**DAC 25/07/23 – 21 PARNELL PLACE NEWCASTLE EAST –
DA2022/00705 – MIXED USE - ALTERATIONS AND ADDITIONS TO
EXISTING HOTEL OR MOTEL ACCOMMODATION (NEWCASTLE
BEACH HOTEL), ANCILLARY FOOD AND DRINK PREMISES AND
COMMERCIAL USE (ANCILLARY HOTEL SPA) AND DUAL
OCCUPANCY (ATTACHED 2 X DWELLINGS)**

PARNELL PLACE

21 Parnell Place, Newcastle East, NSW 2300
LOT 1 /DP815595

SITE PLAN
 SCALE 1:200

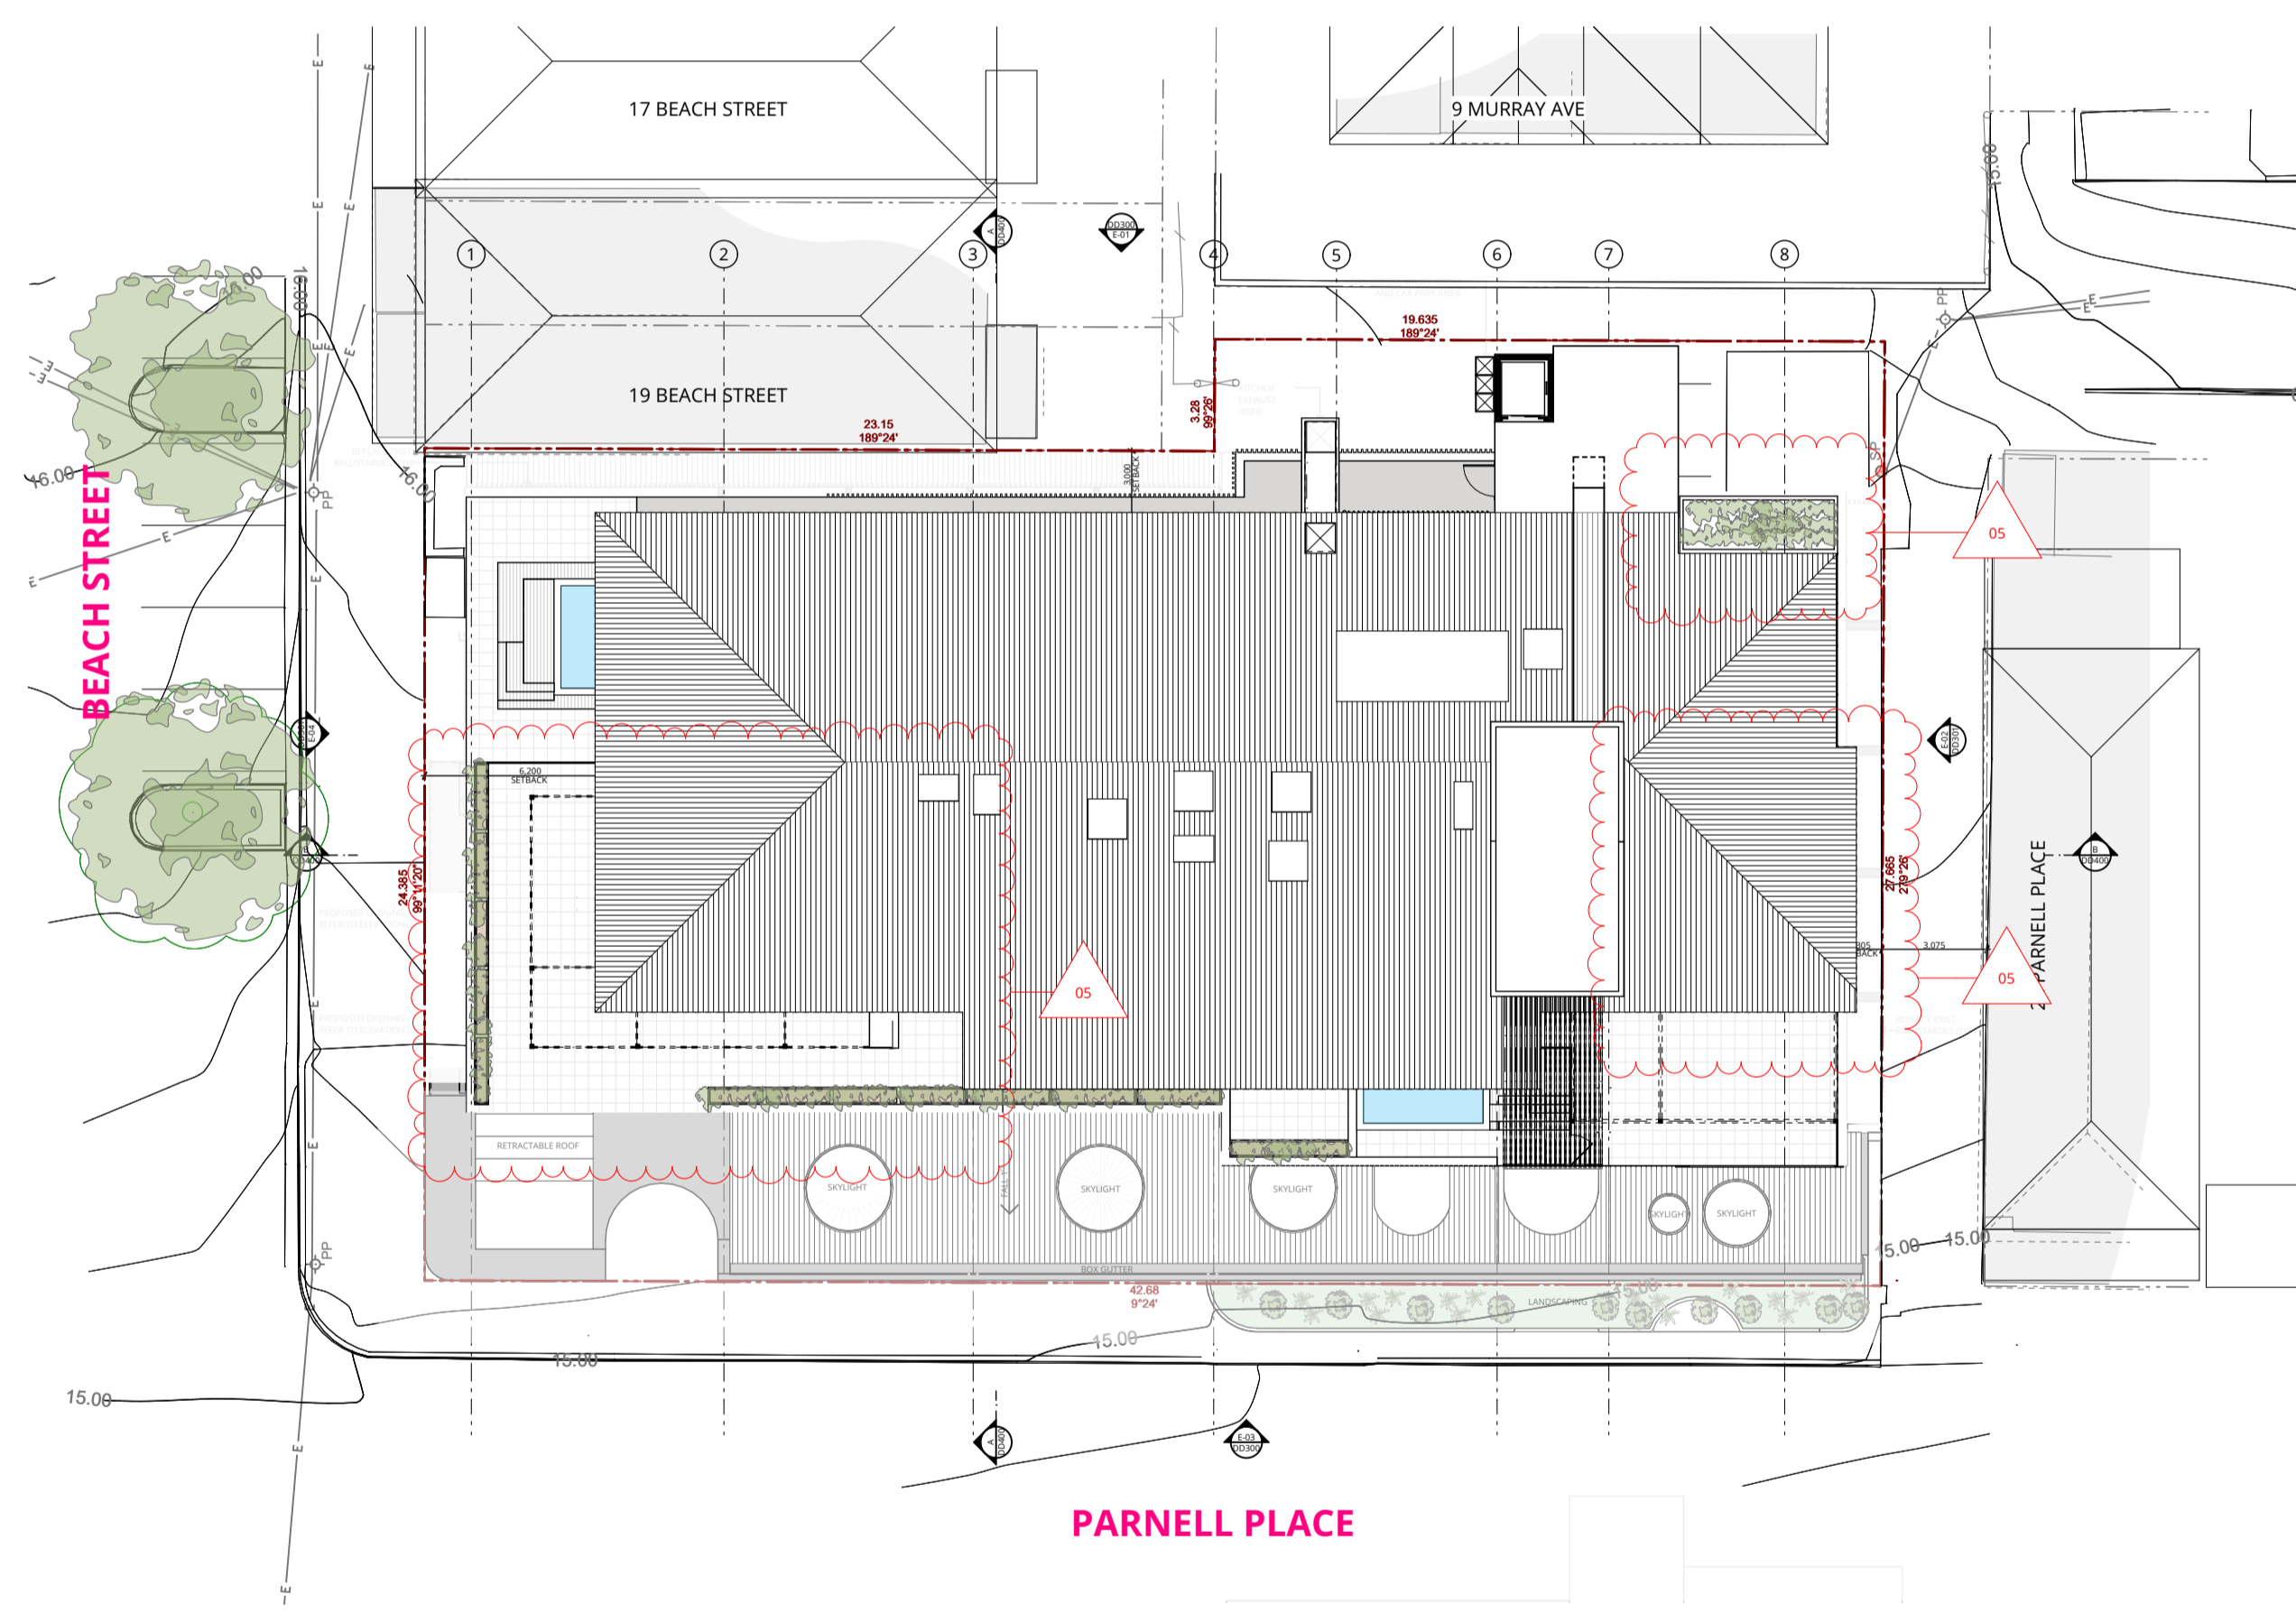
- HERITAGE**
- PENTHOUSE 2 SETBACK FROM SOUTH EAST CORNER BY 1200MM AND LOW GARDEN ADDED TO SOFTEN EDGE AND REDUCE BULK & SCALE
 - EAVE REDUCED BY 600MM TO REDUCE SCALE
 - ADDITIONAL LANDSCAPING TO PENTHOUSE 01 NORTH-WEST CORNER
 - LEVEL 03 SIGNAGE ZONE REMOVED

- WASTE SERVICES**
- BIN AND KEG ROOMS REWORKED TO PROVIDE SPACE FOR MORE BINS, ACCESS DOORS ADJUSTED TO SUIT

DRAWING
 GFA PROPOSED

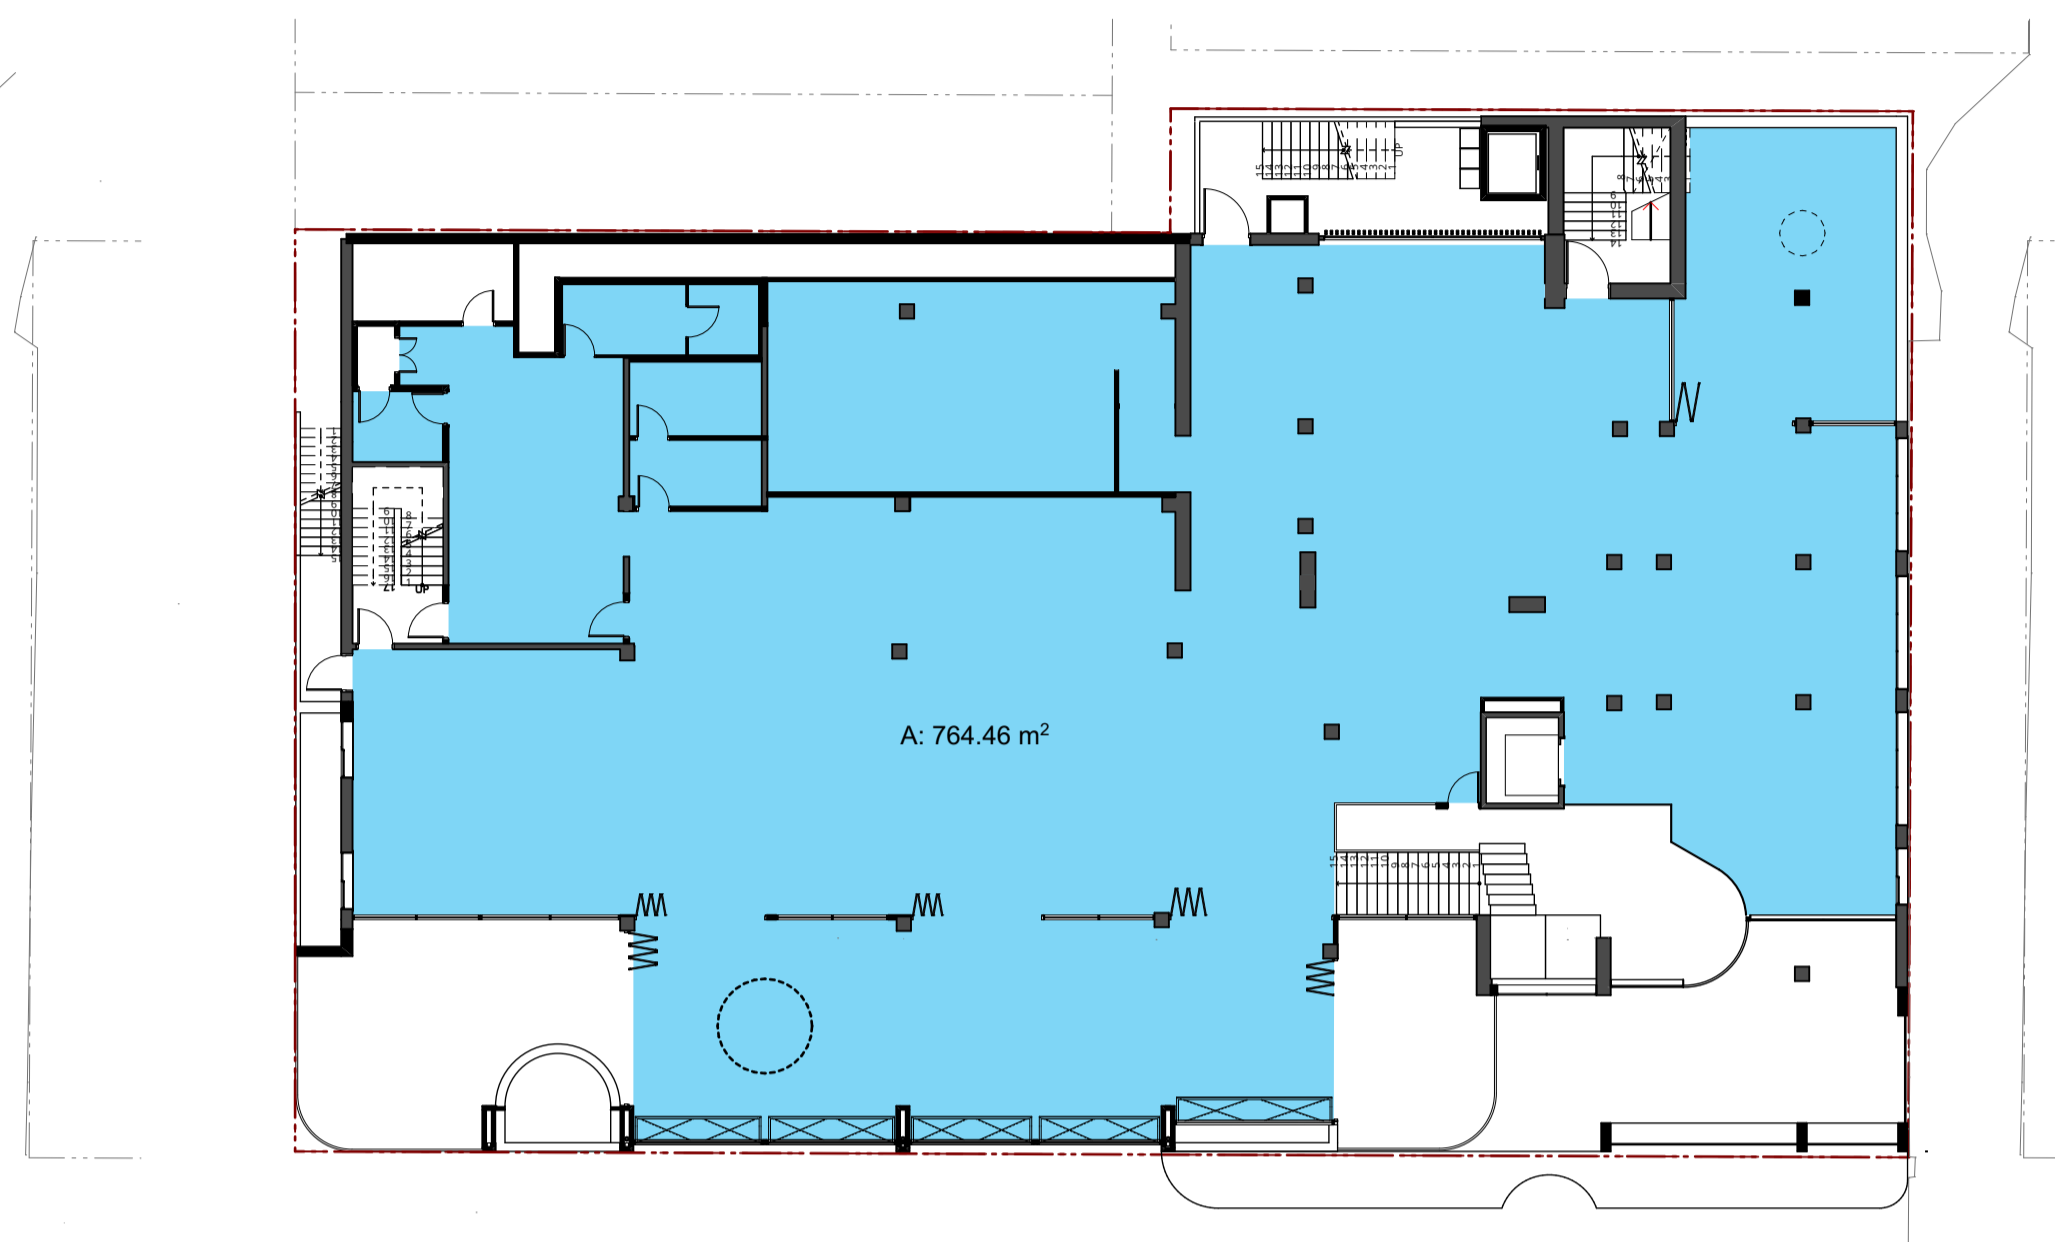
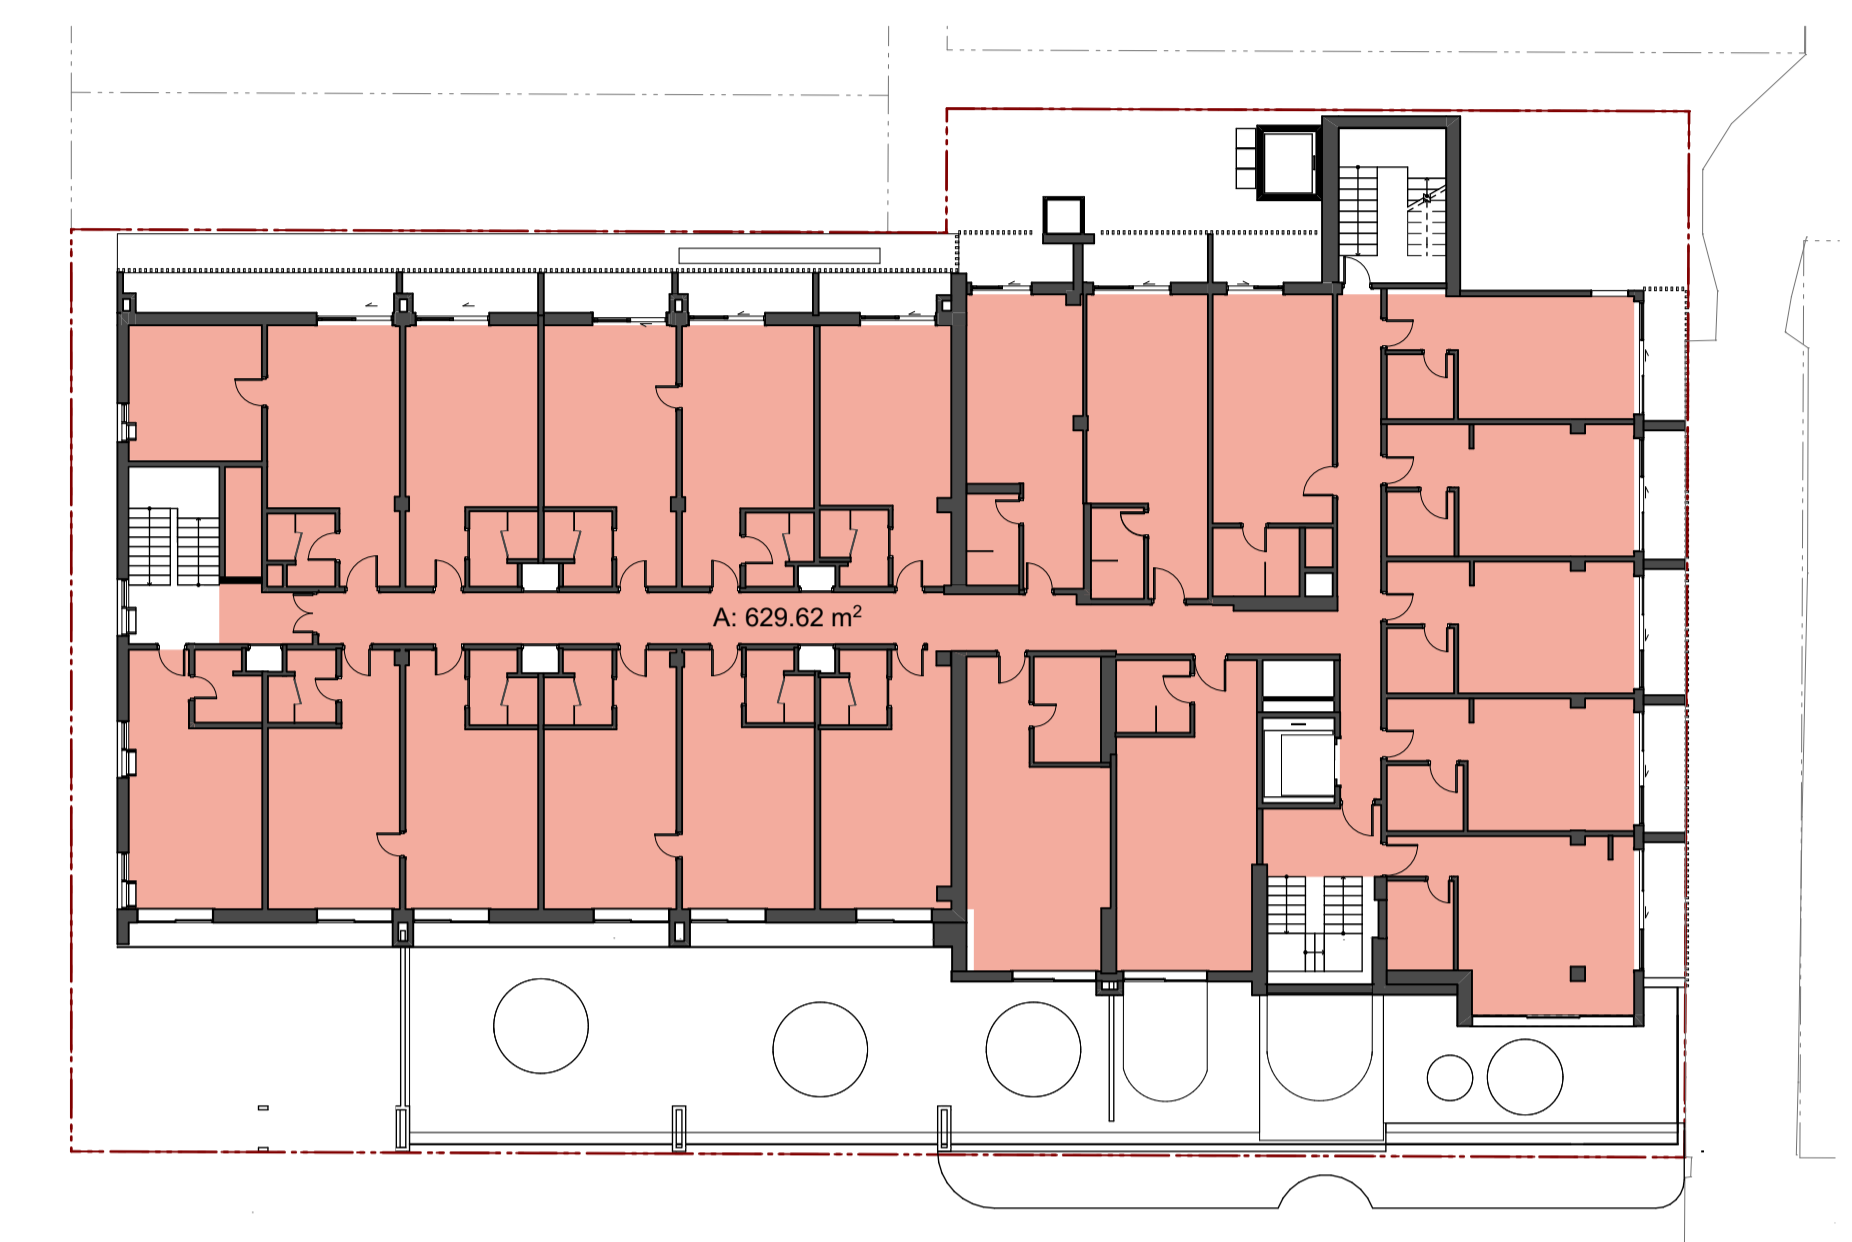
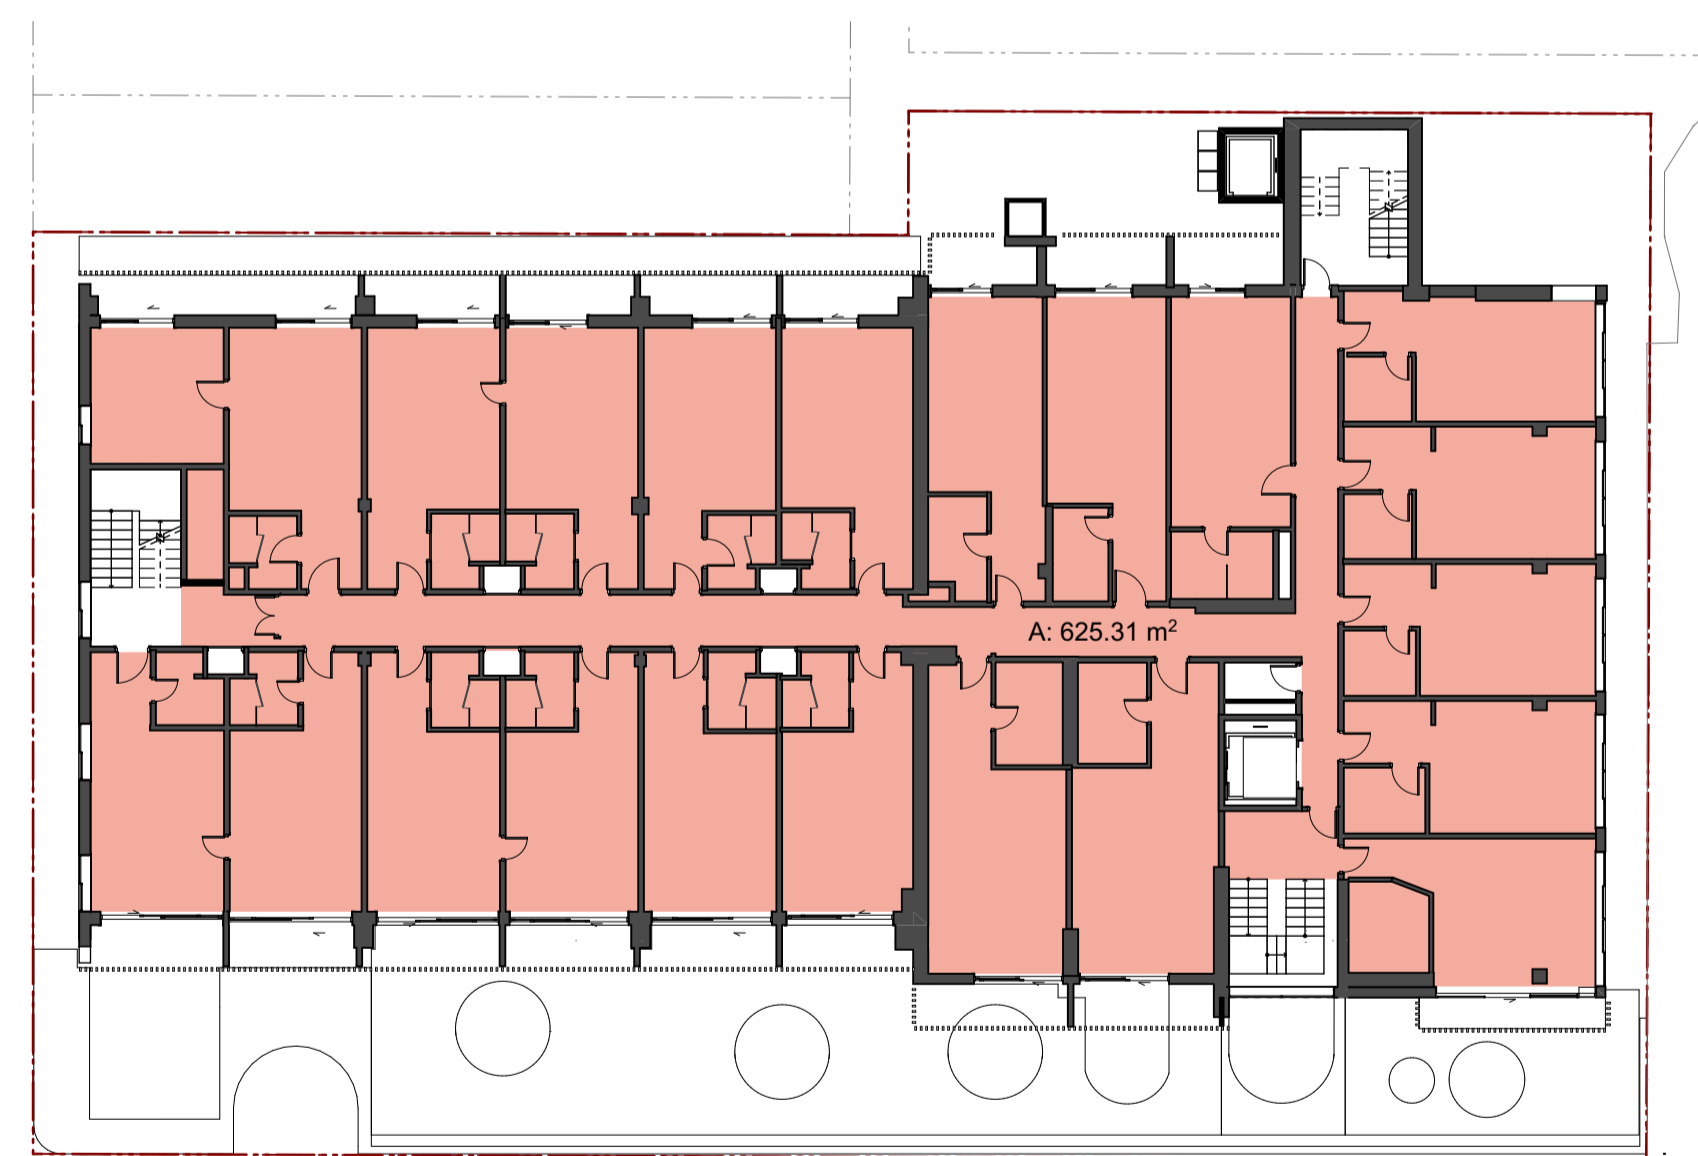
- PENTHOUSE 2 SETBACK FROM SOUTH EAST CORNER BY 1200MM

- BIN AND KEG ROOMS REWORKED TO PROVIDE SPACE FOR MORE BINS
